REFERENCE:	Nova Bus Manuals
SECTION:	05: Rear Axle
RS N°:	MQR 7621-2254
EFFECTIVE IN PROD.:	LD39 (2020OC)

SUBJECT:	ZF Rear Axle AV133
JUSTIFICATION:	Quality issue identified by ZF on 20 screws used for rear axle flange shaft connection. The rework shall be done within next scheduled maintenance or service work.

## Torx screws potential issue at AV133 flange shaft connection

*Figure 1 - Flange shaft screws location*

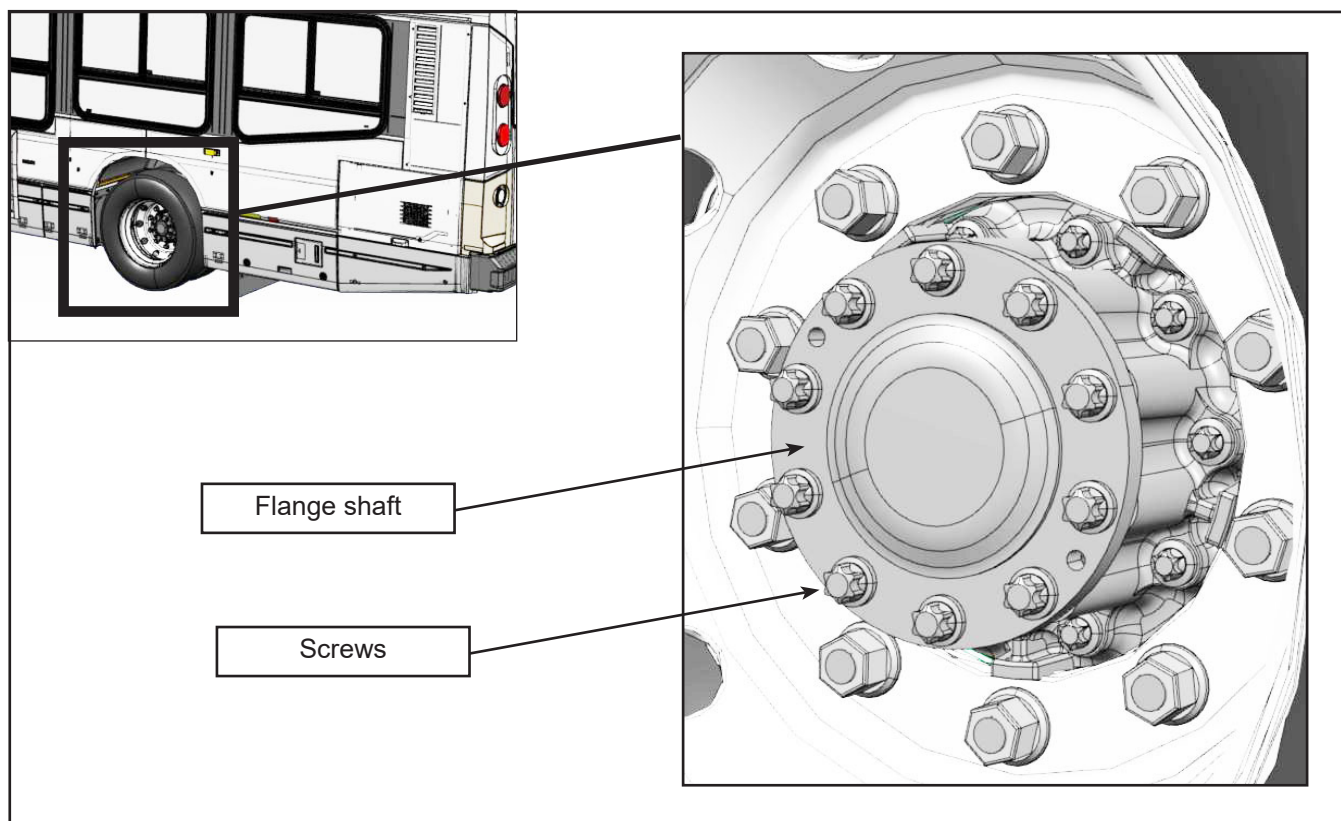
- 1.1. Locate the 20 screws installed on flange shaft connection (Figure 1). There are 10 screws per wheel.

- 1.2. Loosen bolted connection of the flange shaft and remove the screws. **Note:** Do not pull flange shaft out of axle.
- 1.3. Install new Torx screws N8904440 and tighten to required torque of 325 ft-lb (440 N·m).
- 1.4. The vehicle can return in service. ❖
